ADDENDUM #1 - 6/16/2025
REVISED SHEETS: D-1, D-2, D-7, INT-2, INT-3, P-1, P-2, P-4, U-1, U-2, U-3, U-5, W-1, W-2, W-5, W-7, E-1, E-2, E-4, E-7, AND E-8.
REVISION #1 - 8/28/2025
REVISED SHEETS: D-6, INT-2, INT-3, INT-4, INT-6, INT-7, P-1, P-2, P-3, P-4, P-5, P-6, U, W, E, AND ALL X SHEETS.
REVISION #2 - 11/10/2025
REVISED SHEETS: D-6, D-7, INT 1 - INT 4, INT-6, P-1, P-2, P-4, U-1 - U-7, U-12 - U-15, W-3, X-1 - X-7, X-9, AND X-10.
REVISION #3 - 02/20/2025
REVISED SHEETS: U-1, U-4, U-13, U-14, W-1, AND W-7.
REVISION #4 - 04/24/2026
REVISED SHEETS: D-6, INT 1 - INT 4, P-1, P-2. P-4, U-13, X-3 - X-6, AND X-11.

E. MAIN STREET & S. HANCOCK STREET
ASSESSMENT DISTRICT - 2025

CITY PROJECT NO. 15125
CONTRACT NO. 8784

S HANCOCK ST - PLAN & PROFILE

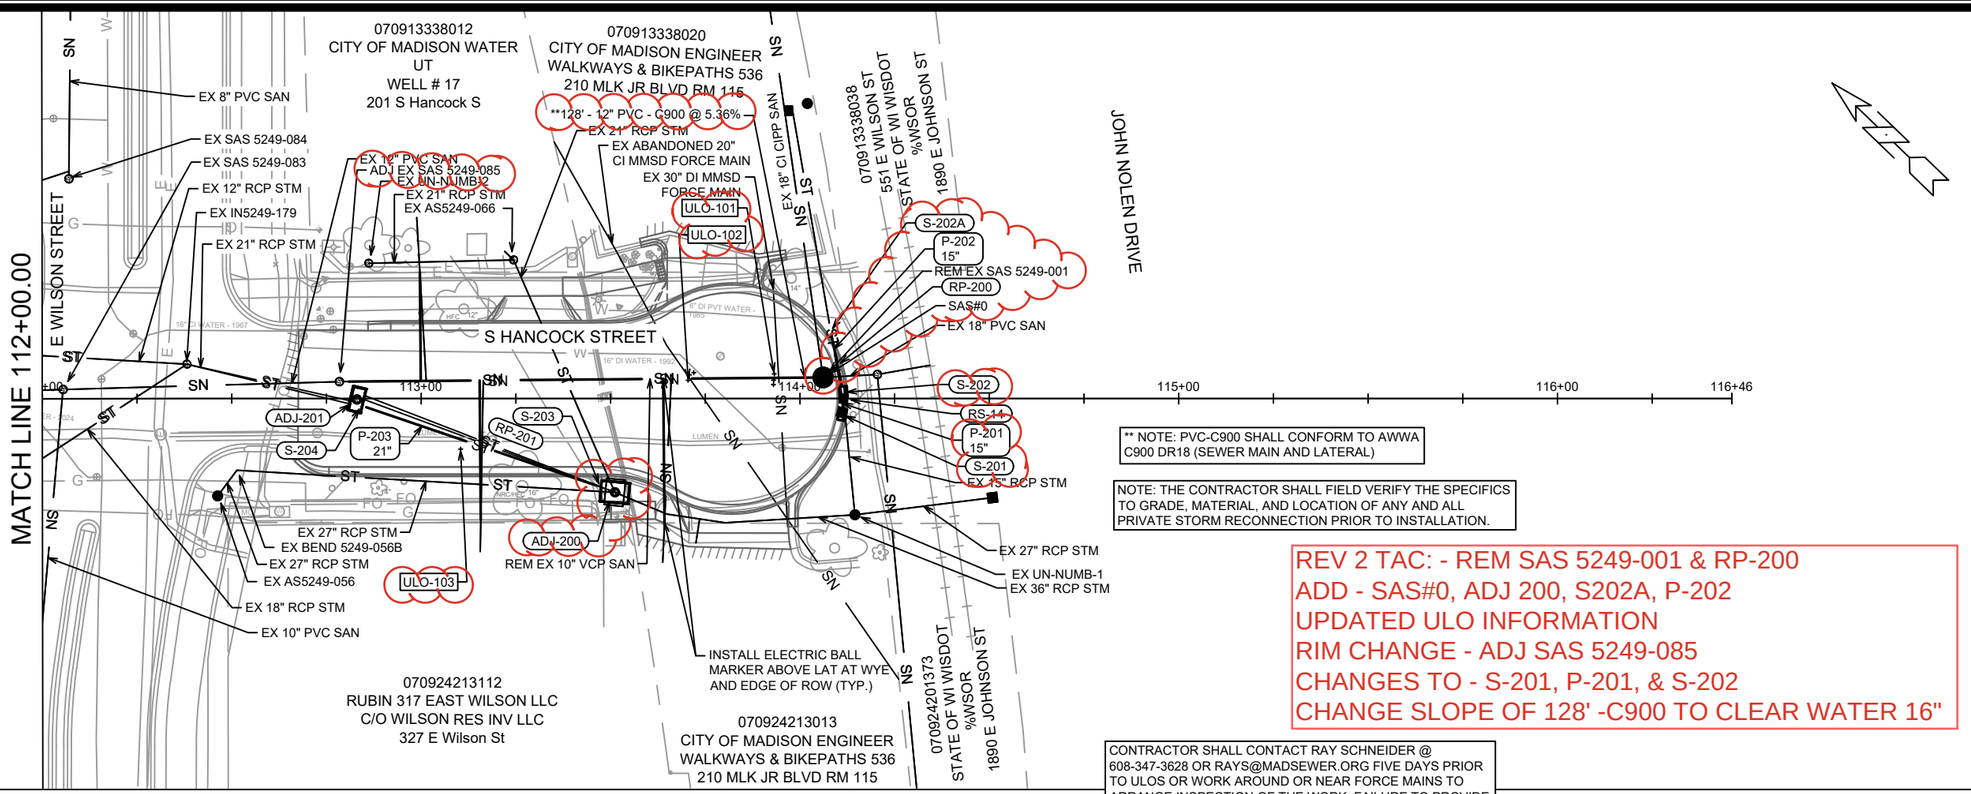
REV 2 TAC: - REM SAS 5249-001 & RP-200
ADD - SAS#0, ADJ 200, S202A, P-202
UPDATED ULO INFORMATION
RIM CHANGE - ADJ SAS 5249-085
CHANGES TO - S-201, P-201, & S-202
CHANGE SLOPE OF 128' -C900 TO CLEAR WATER 16"

ELECTRICAL PLAN - STREET LIGHTS
E. MAIN STREET & S. HANCOCK STREET ASSESSMENT DISTRICT - 2025
MADISON, WI

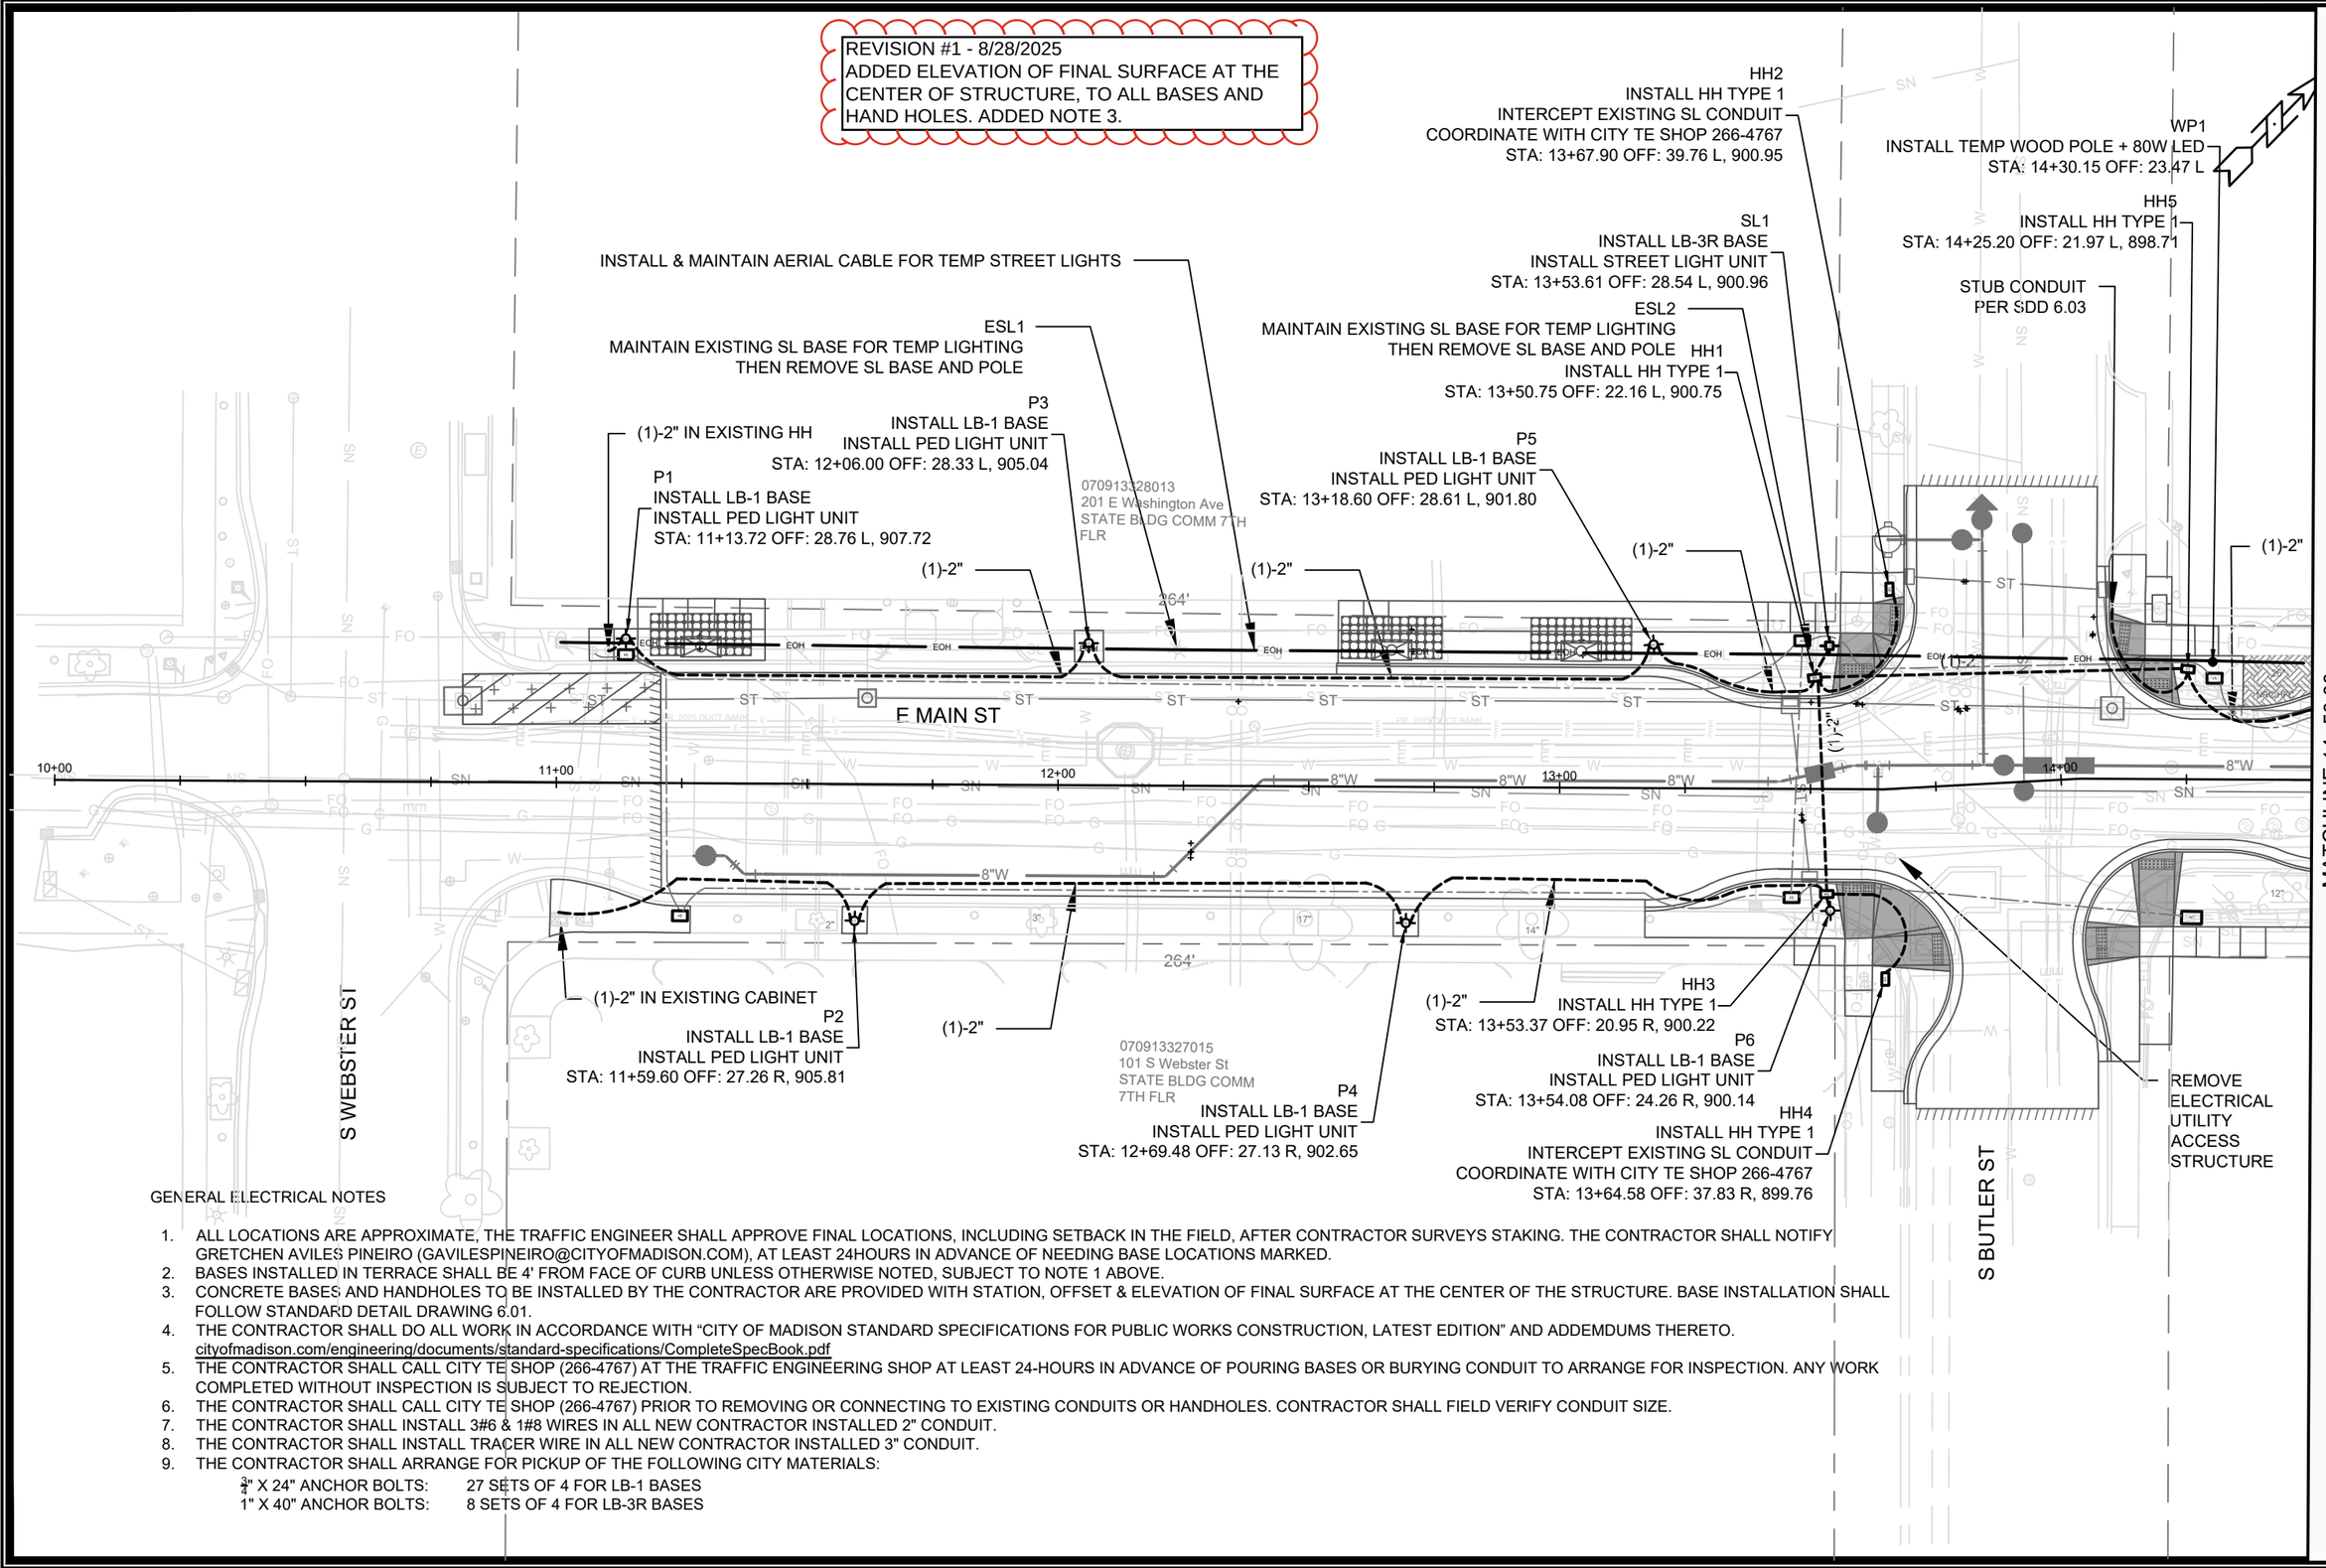
REVISION #1 - 8/28/2025
ADDED ELEVATION OF FINAL SURFACE AT THE CENTER OF STRUCTURE, TO ALL BASES AND HAND HOLES. ADDED NOTE 3.

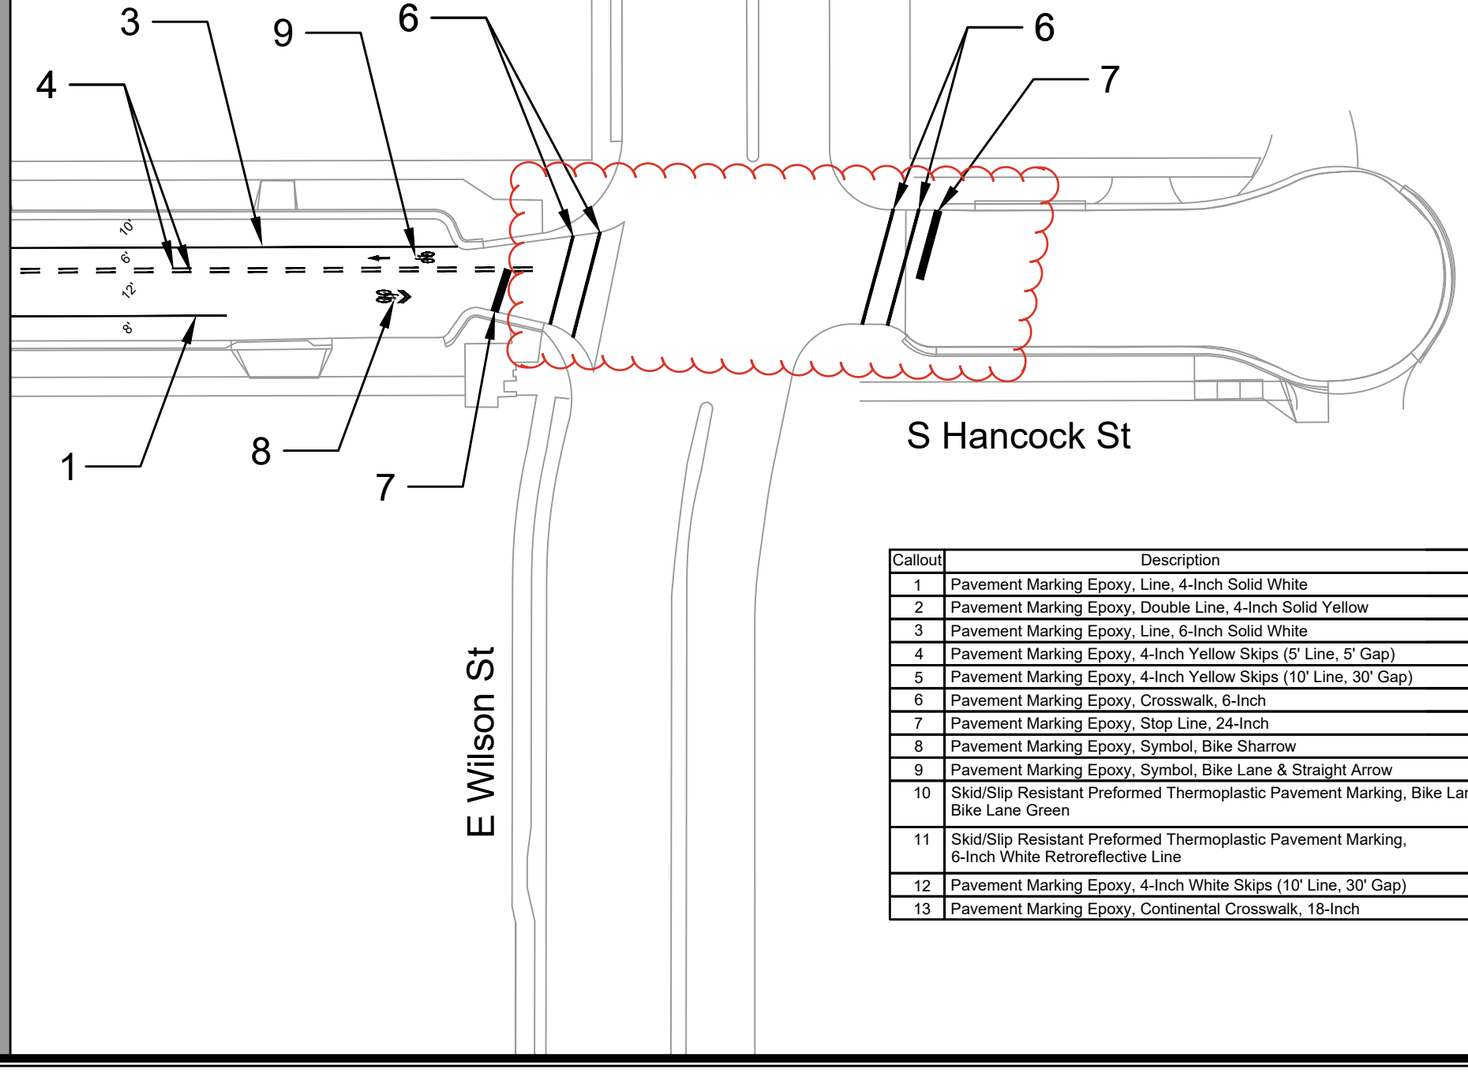
ADDENDUM 1 - 6/24/2025
1. INCREASED CURB REMOVAL/REPLACEMENT ON SOUTHWEST SIDE OF S. HANCOCK STREET.
2. ADJUSTED CROSSWALK MARKINGS TO MATCH EXISTING GEOMETRY.

X-1

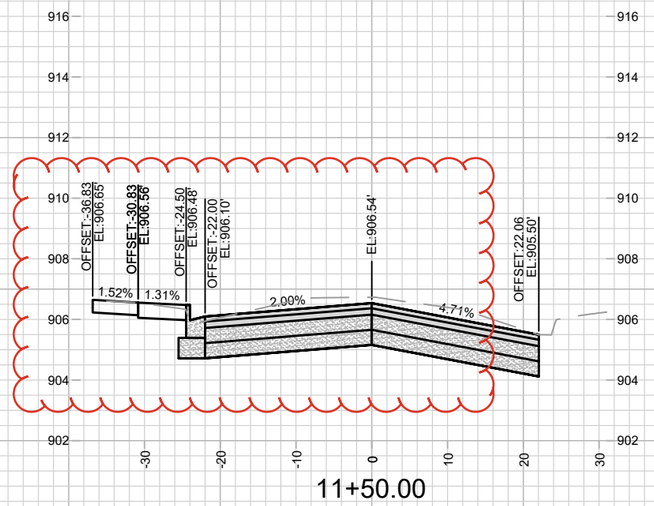
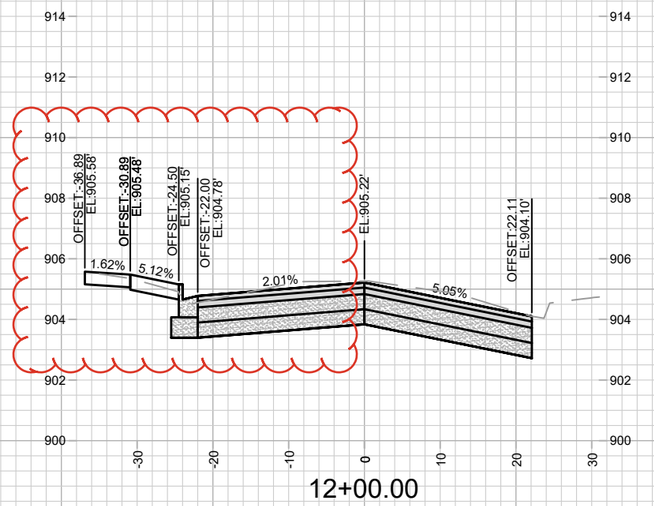
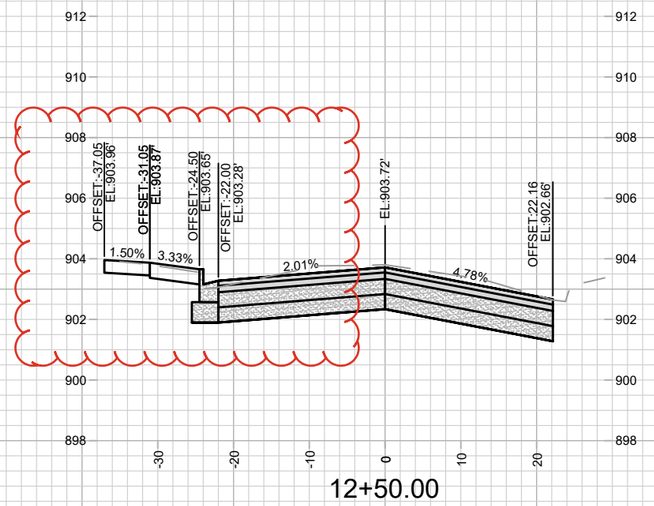
REVISION #1 - 8/28/2025
ADJUSTED MAIN ST CENTERLINE GRADES.
